RE: C-144 Conditions of Approval for a Below-grade Tank Permit
Facility or Well Name: Dryden 2E
API Number: 30-045-26002
Location: Unit Letter I, Section 22, Township 28 North, Range 10 West, NMPM
San Juan County, New Mexico

The Oil Conservation Division (OCD) has reviewed Koch Exploration Company, LLC's (Koch) application, dated September 9, 2009, to permit an existing below-grade tank pursuant to 19.15.17 NMAC. Koch provided information in the application packet which revealed issues with the operation of the current design in regards to the conditions at the proposed location. Koch application revealed issues of concern such as shallow ground water (a 17 foot separation from the bottom of the tank) and the below-grade tank's proximity within 250 feet of a wetland. Also, the assessment regarding the setback to a continuously flowing or significant watercourse was not indicated as being based upon ordinary high-water mark and the attached aerial photos and topographic map demonstrate environmental issues with potential impacts to the nearby watercourse.

**Pit, Closed-Loop System, Below-Grade Tank, or
Proposed Alternative Method Permit or Closure Plan Application**

**Attachment

Figure 2
Below-grade Tank Retrofit Plan

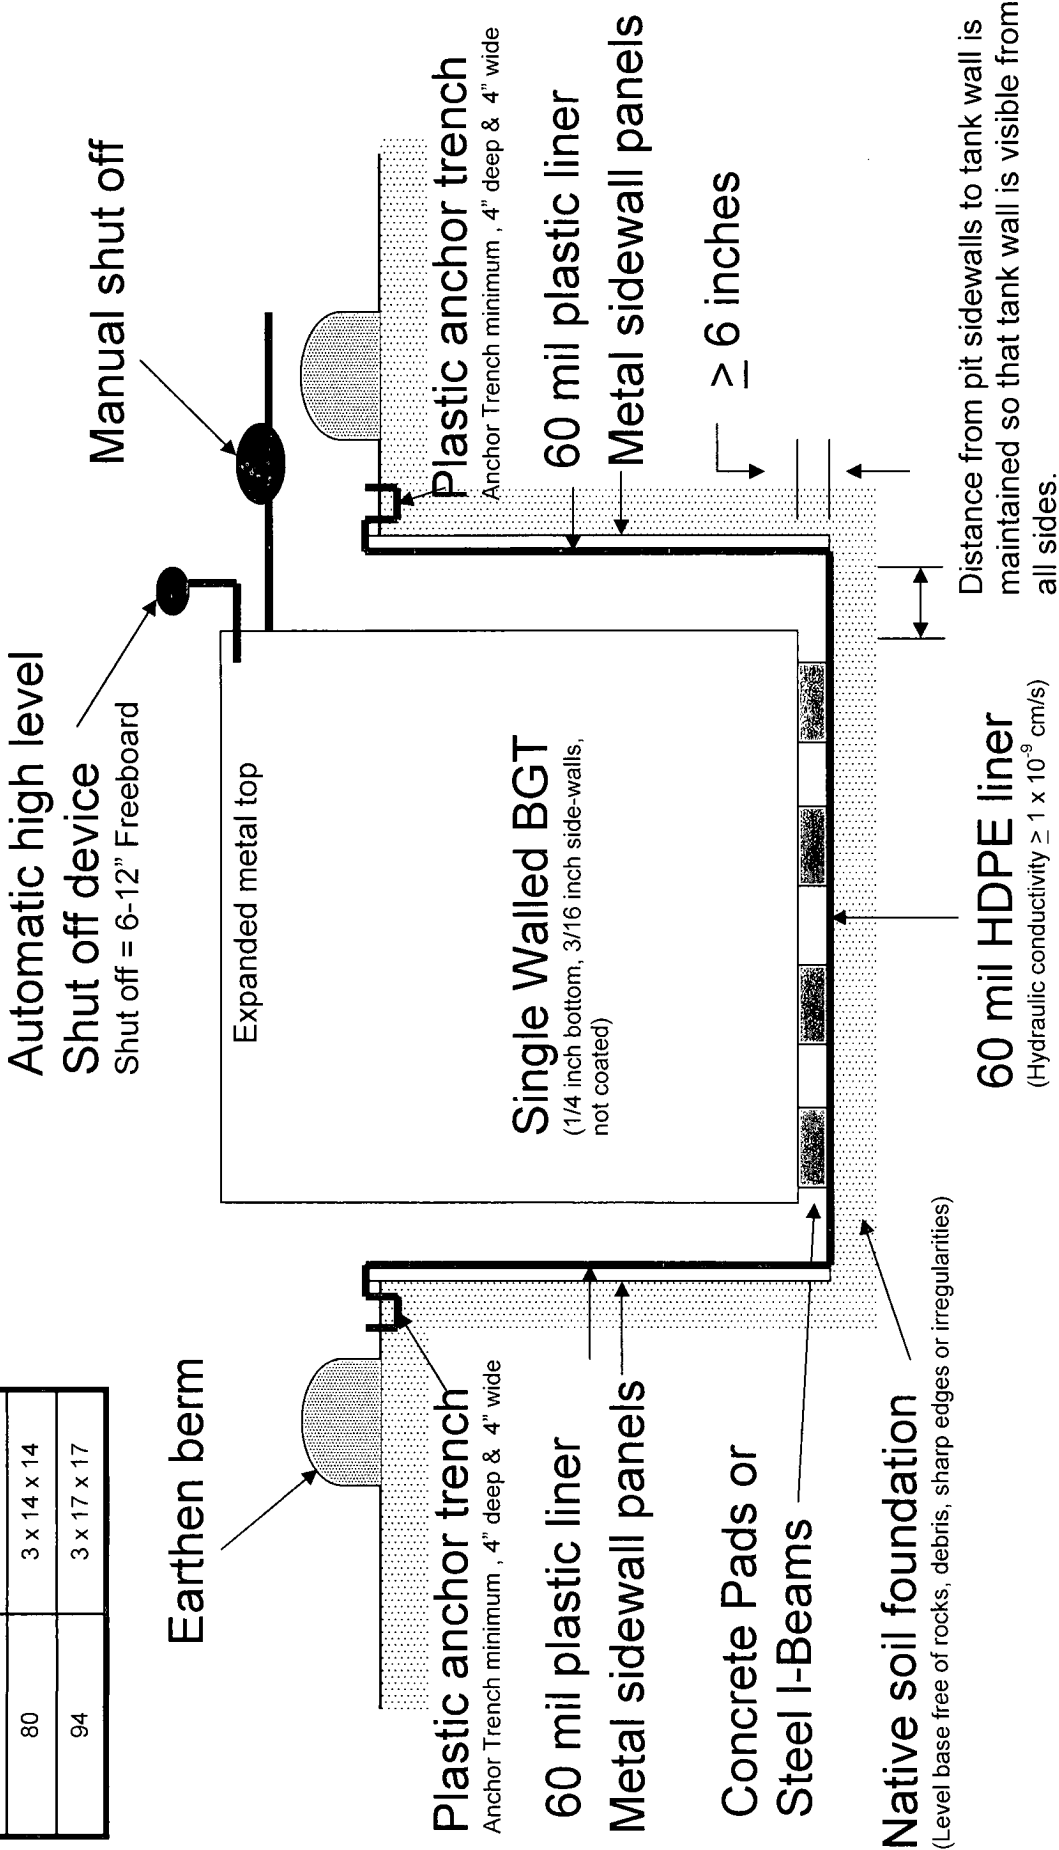
- Koch shall retrofit or replace the existing below-grade tank with the proposed design (Figure 2) approved in the permit application packet within one calendar year of this approval, by December 6, 2010.
- If Koch chooses not to pursue or complete the retrofit or replacement of the existing below-grade tank, Koch shall complete the closure of the below-grade tank pursuant to the approved closure plan within one calendar year of this approval, by December 6, 2010.
